# **PAM-HSL AIR ARCHITECTURAL DESIGN COMPETITION**

## **NOTES TO QUERIES & ANSWERS**

**QUERIES & ANSWERS**

Query 3 - to provide drain layout and invert level on lot 20600 & 20604

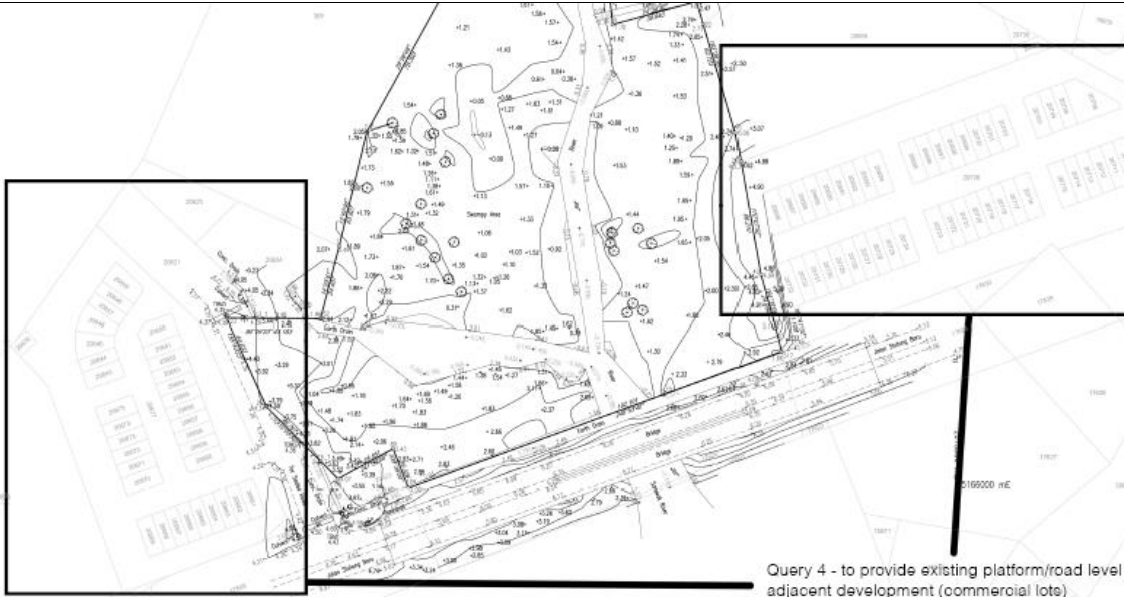
Query 4 - to provide existing platform/road level adjacent development (commercial lots)

Answer	No Information available
Q115	To provide drain layout and drain invert level on lots 20600 and 20604 (missing link between KPJ and our proposed site)
